## **SWEENEY BLOCKS**

4440 FAUNTLEROY AVE SW, SEATTLE WA 98126  
SDCI Project #3035693-LU | RECOMMENDATION | Meeting Date: November 18, 2021

Materials

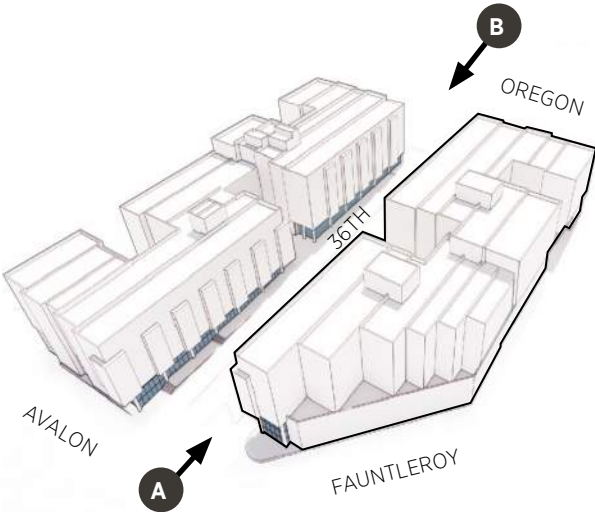
a. The Board generally supported the material concept shown and the Board requested the final material design create a distinct difference between the two buildings. The Board noted the same material combinations appeared to be applied to this building and the building to the east. While the material pallets can be similar, the two buildings should look distinct from one another.

The Board also noted the final material application should include more wood, as it relates to the concept proposed for the building and the history of the site, along with other high-quality materials that relate to wood.

While the buildings share a similar concept, a multitude of colors, textures and patterns are used to create distinct identities for each building. At the north end of the site the upper massing of the subject building uses a lighter material palette with a white window frame and light balconies in contrast with the East Building which uses a darker palette with a dark window. The buildings will look related but unique.

Real wood is used at the street level and throughout the landscaping. Higher on the building we are planning to use products that looks like wood but have a fire rating that works with the Type IIIA construction. For the “wood-look” material we are using at products that provide texture in addition to a wood pattern.
